**Land at Greenmans Lane
Off Sodam Lane
Dauntsey
SN15 4HN**

Surface Water Drainage Strategy

**S25-148/SWDS
April 2026**

Revision 2

LIDAR
Approx. Built Area in Dash

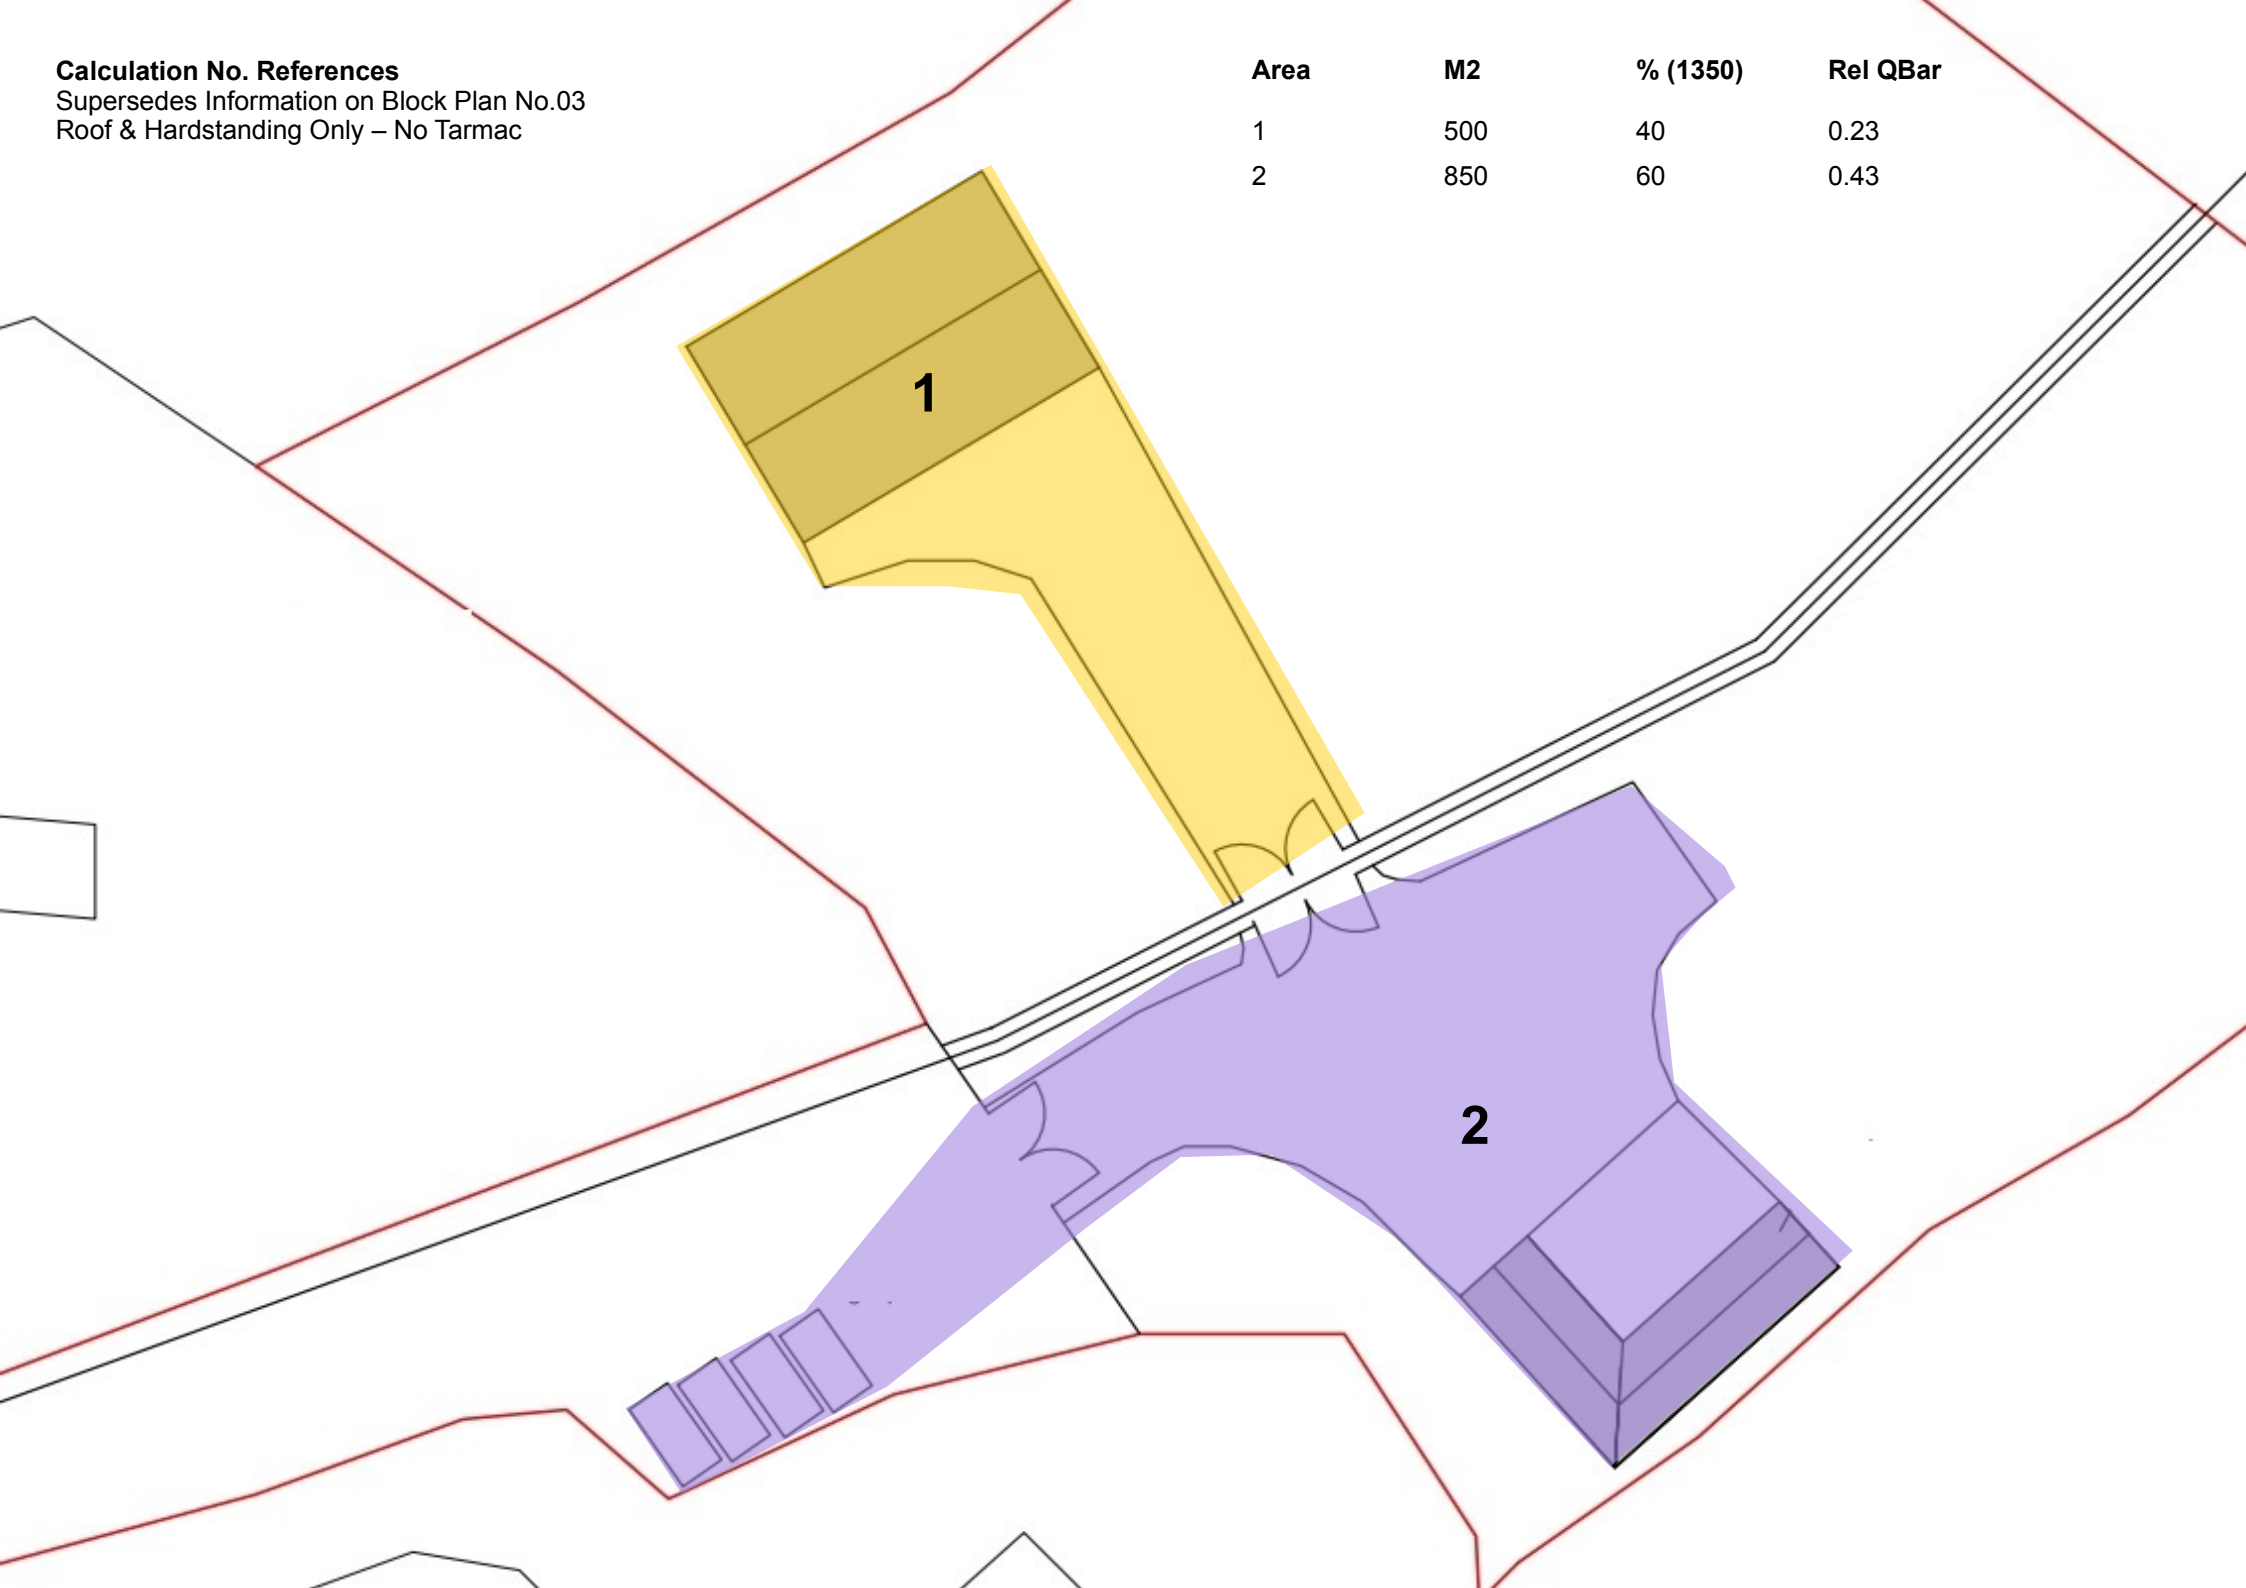
A clearly labelled drainage layout plan showing the pipe networks and any attenuation tanks or swales. The plan should show any pipe node numbers referred to within the drainage calculations.

We are not including pipe volumes, calculations. All pipe work to building regulations.

Calculation No. References
Supersedes Information on Block Plan No.03
Roof & Hardstanding Only – No Tarmac

Drainage Features
Supersedes Information on Block Plan No.03

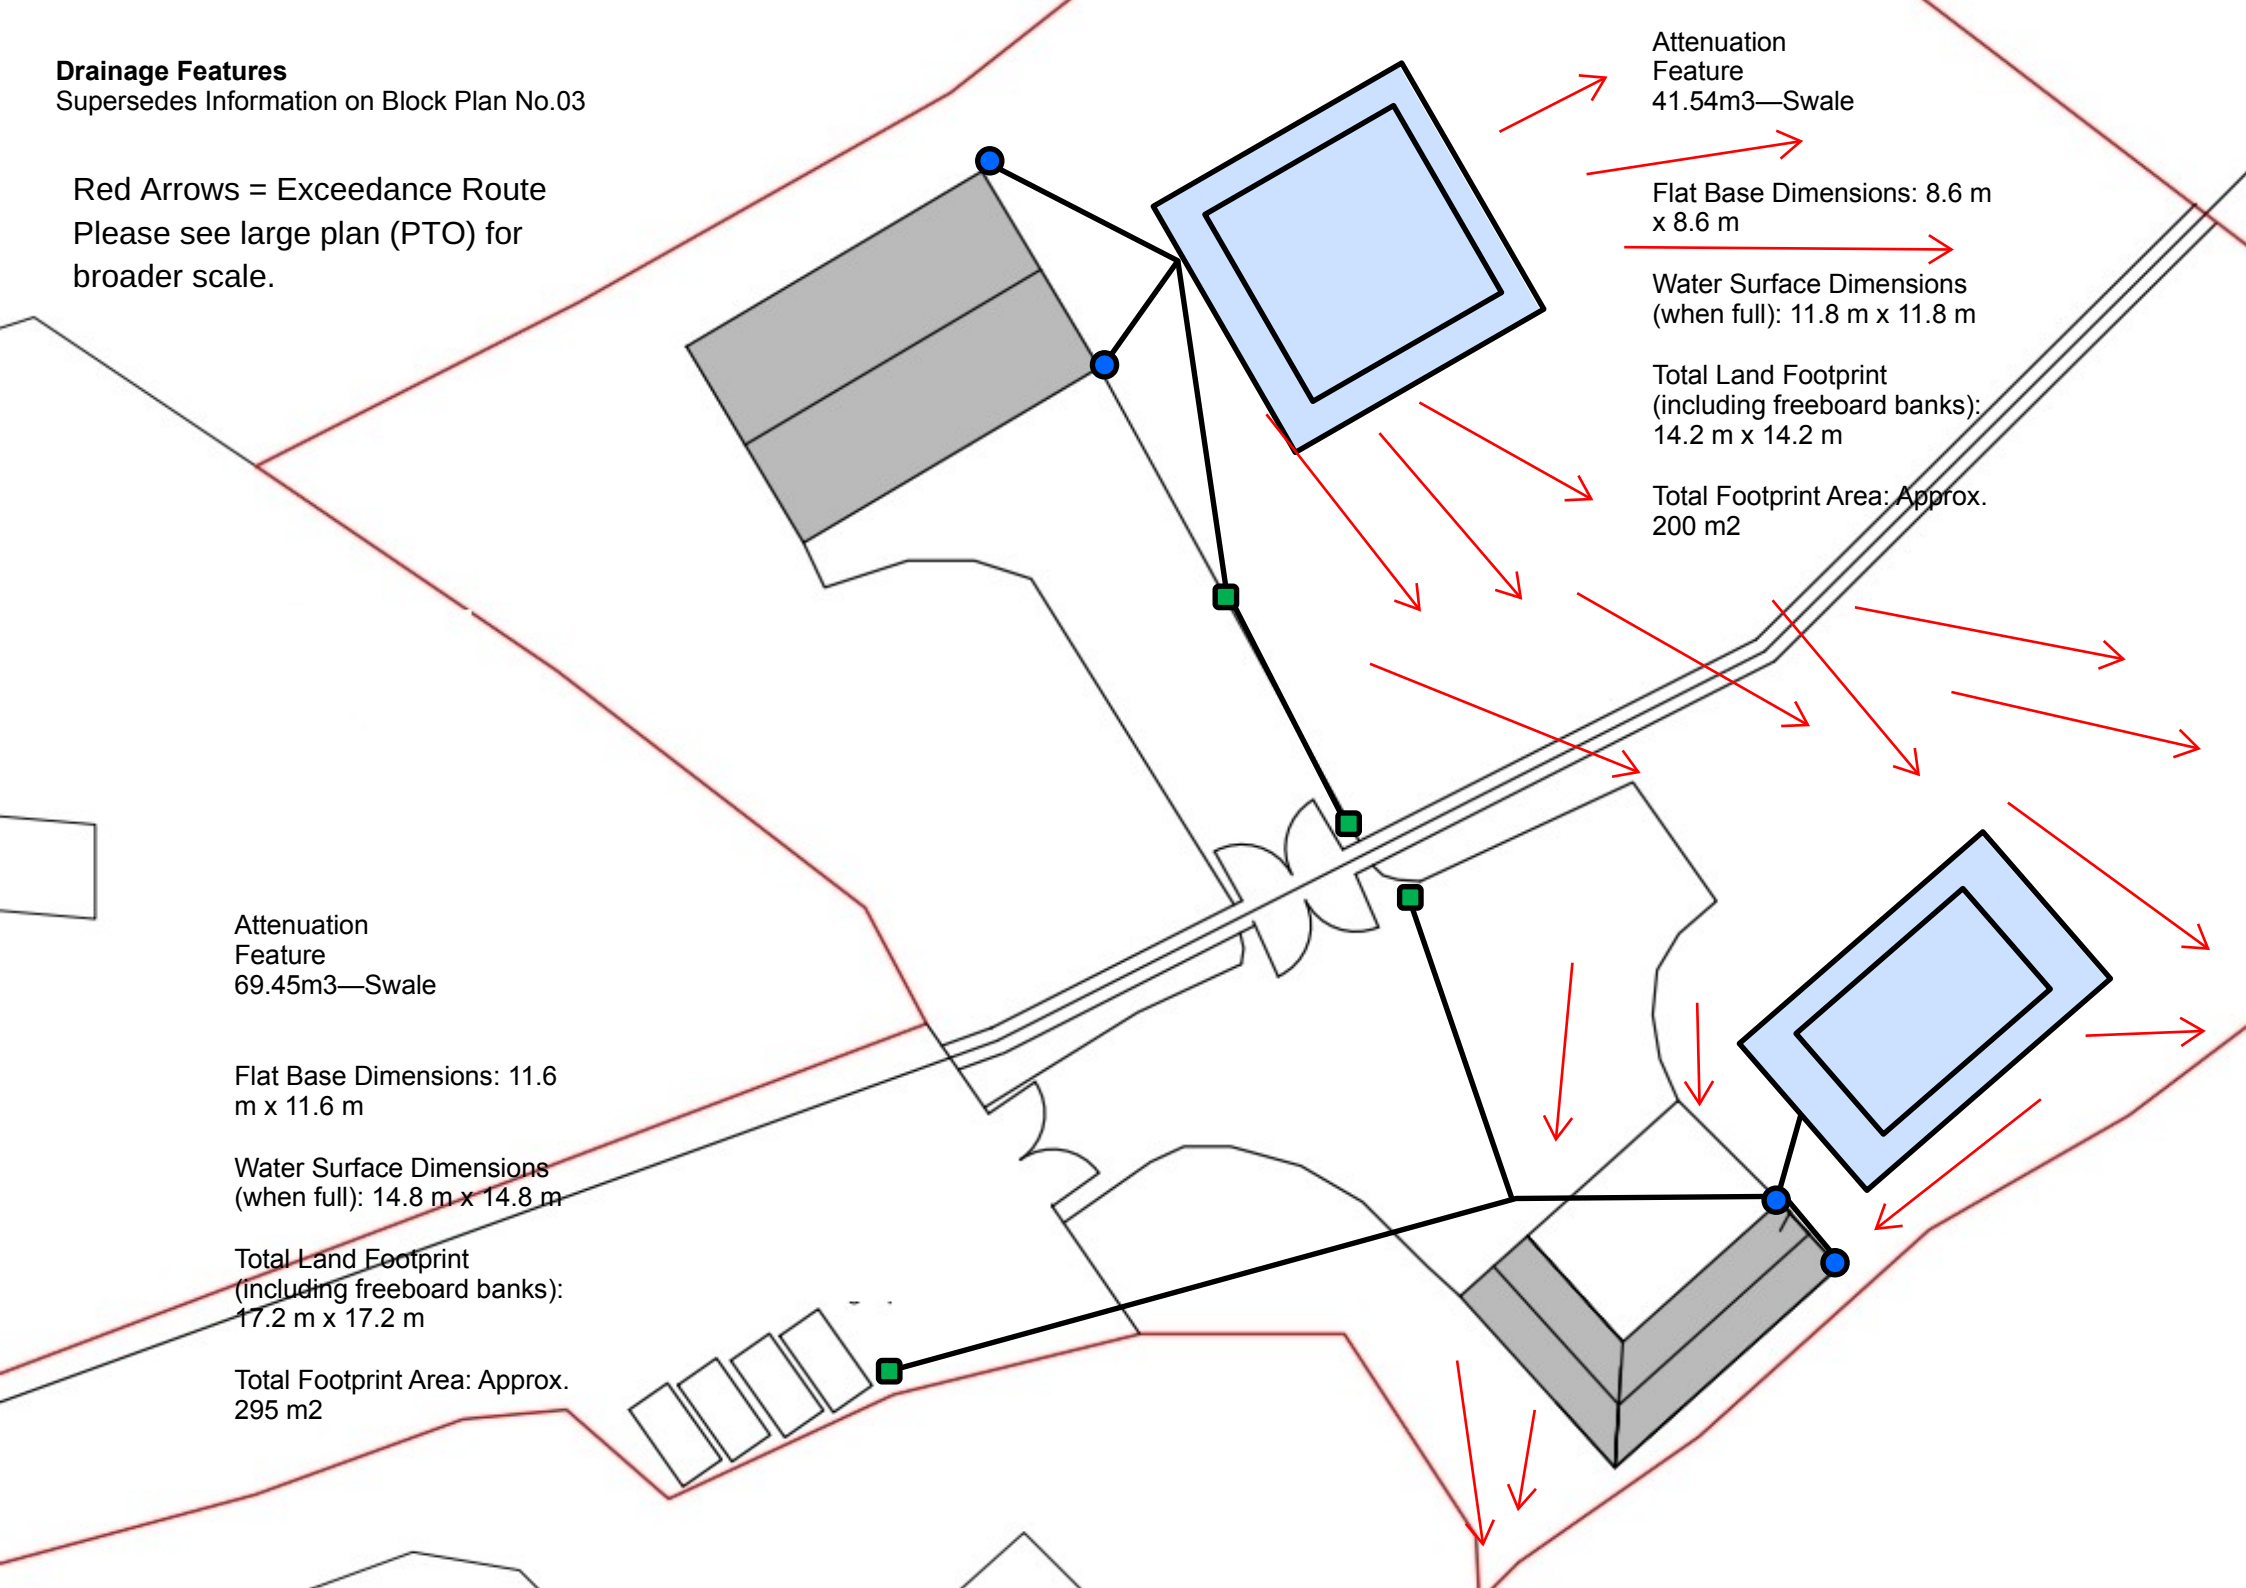
A plan showing the cross sections and design of the tanks.

No development shall commence on site until the applicant has shown overland exceedance routes on the drainage plan for flows in excess of the 1 in 100 year plus climate change (40%) rainfall event.

We will use swales, as shown on plans.

Red Arrows = Exceedance Route
Please see large plan (PTO) for
broader scale.

Attenuation
Feature
41.54m³—Swale

Attenuation
Feature
69.45m³—Swale
